CROW BUTTE RESOURCES, INC.

(Marsland Expansion Area)

Exhibit Title: Dr. Kreamer Opinion August 16, 2018

**EXPERT OPINION TESTIMONY OF DAVID K. KREAMER**

OST005 at 4: Dr. Kreamer re-drawn Figure 2.7A-6, with Theis type-curve matching early time in red. Early data points are circled – late time data below type curve indicates recharge.

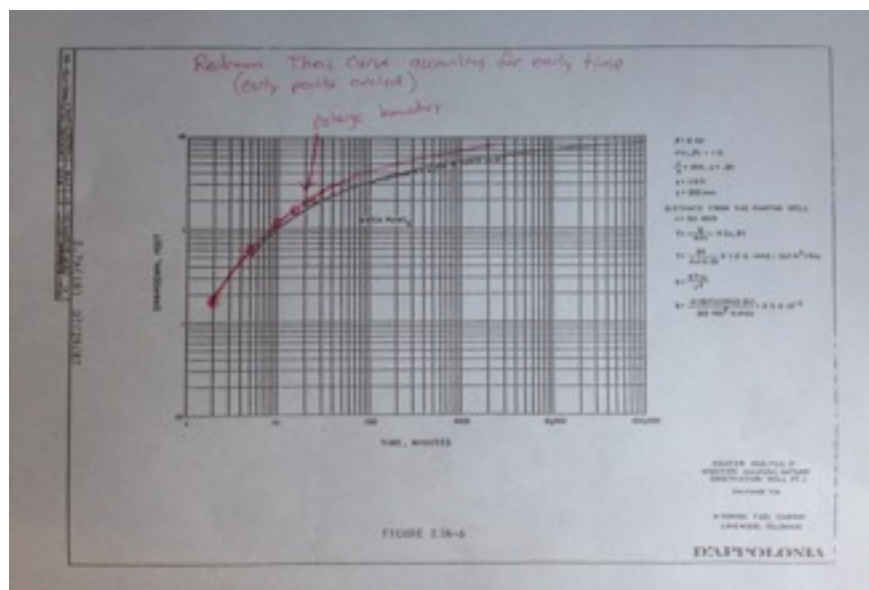
**Basis:** Previous hydrogeologic testing identified non-homogeneous anisotropic conditions in properties adjacent to the MEA. Ten aquifer tests were performed at the or around the Crow Butte Resources (CBR) site and five of those tests were invalidated by CBR because of possible vertical leakage (Tests 5 through 9 in 2004 and 2005). Information on those pumping tests was not provided. For CBR Aquifer Test One the CBR report explicitly states on page 2.7A (15) [OST006 at 16], *“Figures 2.7A-4 through 2.7A-7 give the apparent indication of leakage especially noticeable at late times.”* On page 2.7A (8) [OST006 at 9] in the CBR report the authors state that, *“Based on significant deviation of the pump test data from the Theis type curve in the original analysis the USNRC questioned the use of a non-leaky analysis method in the data.”* On page 2.7A (22) [OST006 at 23] they state, *“Examination of the drawdown/time curves plotted for observation well indicated that some leakage from confining bed occurred during the pumping test.”* Additionally, Dr. David Kreamer in testimony regarding pumping test one showed departure from the classic Theis curve consistent with leakage (See Exhibits 1 and 2 below). [OST005 at 4] This same departure is evident in the MEA pumping test. [CBR016 at 80-96]
